Impacts of City of Burnet draft wastewater discharge permit on Hamilton Creek and Lake Travis

Chris Herrington, PE City of Austin Watershed Protection Department

SR-10-04. April 2010

Figure 1. Predicted change in daily chlorophyll- α concentrations from current "no discharge" conditions under the draft permit in Lake Travis at Hamilton Creek (μ g/L chl- α).

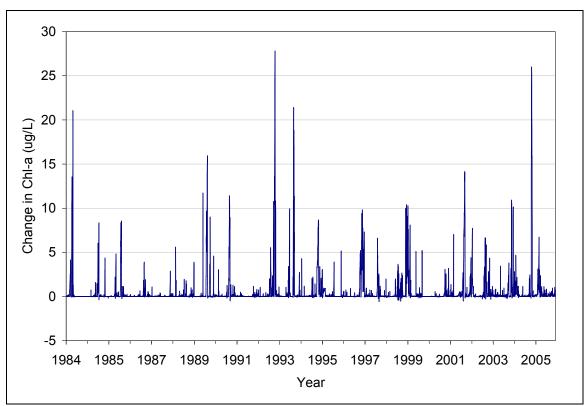
Under either the current permit or the new draft permit versus current "no discharge" conditions, the Burnet discharge is predicted to increase the median concentrations of nutrients in Lake Travis at the confluence with Hamilton Creek (Table 4). The draft permit is predicted to increase the median concentration of nitrogen in Lake Travis, and slightly reduce the concentration of phosphorus versus the current TPDES permit. Increases in predicted daily chlorophyll- α concentrations in Lake Travis at Hamilton Creek are substantial in critical time periods when comparing the draft permit versus current "no discharge" conditions (Figure 1), and measurable increases in chlorophyll- α concentrations are predicted even at the most downstream end of Lake Travis near Mansfield Dam.

Maximum increases of chlorophyll- α from the discharge in Lake Travis are typically predicted to occur in the summer months. Over the 22 year simulation period (excluding 4 dry years with less than 122 summer days in model output), summer mean chlorophyll- α concentrations in Lake Travis at the confluence with Hamilton Creek are predicted to increase by more than 15% with either the current or new draft permit versus existing "no discharge" conditions, with a maximum summer mean increase of 45.6%. There is a 0.7% increase in predicted summer mean chlorophyll- α concentrations in Lake Travis at Hamilton Creek with the new draft permit versus the current TPDES permit. Three summer means in Lake Travis at Hamilton Creek are predicted to shift from a mesotrophic state (4-10 μ g/L) to a eutrophic state (>10 μ g/L) in the simulation period under the draft permit versus current "no discharge" conditions. An additional 353 days are predicted in which Lake Travis would be eutrophic at Hamilton Creek during the simulation period under the draft permit versus the current "no discharge" conditions. Increases in annual average summer chlorophyll-a concentrations will be evident throughout Lake Travis from Hamilton Creek confluence to the downstream Mansfield Dam (Figure 2) under the new draft permit versus current "no discharge" conditions.

More stringent effluent limits or reductions of flow thru continuation or expansion of the existing land application method could reduce the degradation of the creek and the lake from the Burnet wastewater discharge. These restrictions should be written into the permit; otherwise, the full discharge amount must be used in evaluating the current draft. Based on the current modeling results, not available to TCEQ at the time the existing Burnet TPDES permit was issued, the current Burnet TPDES permit should not have been issued as it results in more than a *de minimus* degradation of the water quality of Hamilton Creek and Lake Travis. As Burnet has responsibly chosen to operate their existing facility as primarily a "no discharge" facility, the evaluation of the new draft permit should be conducted considering the current, "no discharge" water quality conditions. Because the current permit is effectively not being used, evaluation of the proposed draft permit versus the current permit limitations, is not in keeping with the spirit of anti-degradation, anti-backsliding environmental regulations. TCEQ is required under 30 TAC §311.5
